INVITATION FOR BID

Date: September 6, 2017
IFB #: IFB-CL-1801
Bid Name: Installation of Rubber Tiles-Variou Locations
Due Date: **September 13, 2017 @ 2:00 p.m.**

Addendum #2

Please see the following amendments to the IFB for the Installation of Rubber Tiles at Various Locations.

FLOOR PLAN
SCALE: 1/4" = 1'-0"

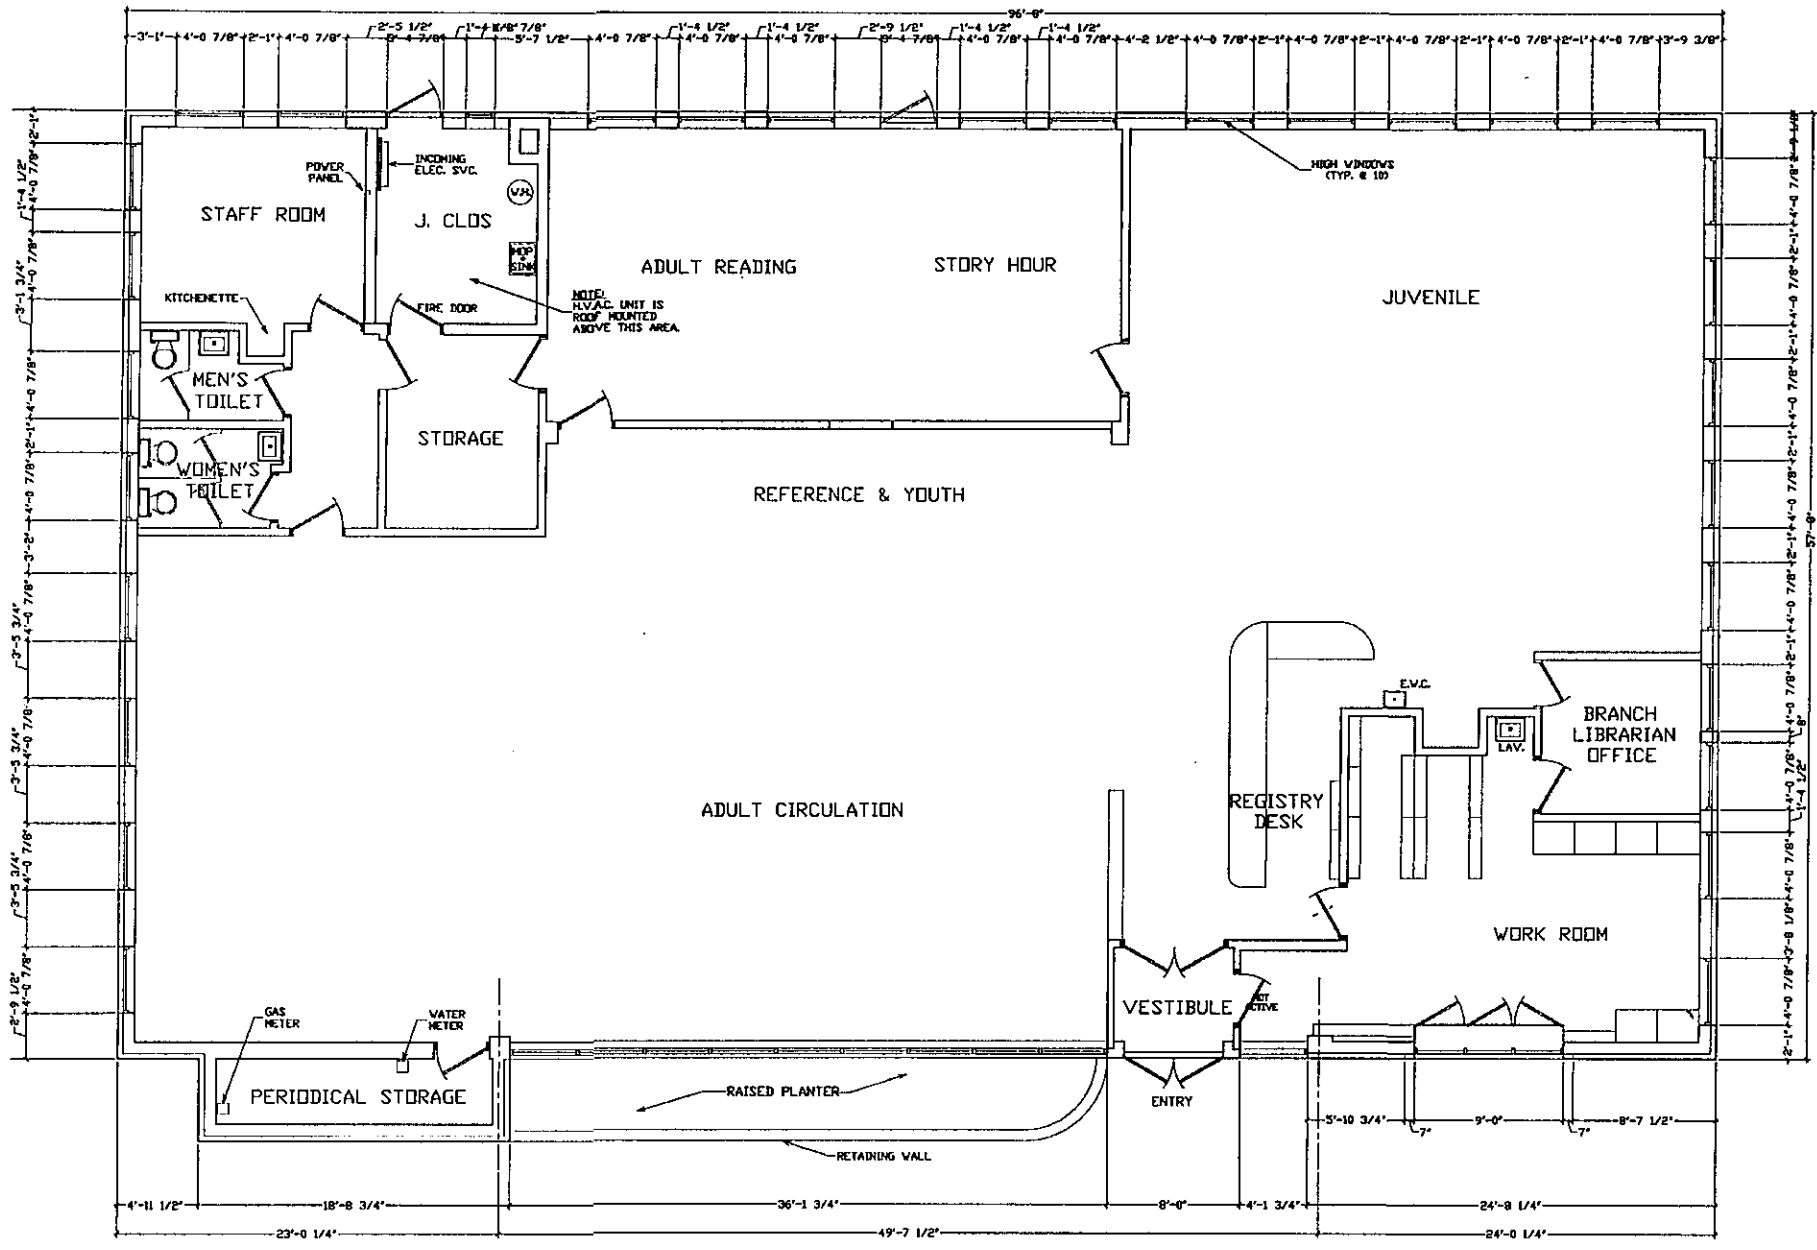
- 4.) In lieu of rubber tiles, VCT tile shall be installed in the following locations at the **Franklin Branch-Only**.
 - a. Staff Room (Kitchen)
 - b. Storage (Computer Server Room)

- c. Vestibule (E. McNichols Entrance of Library)
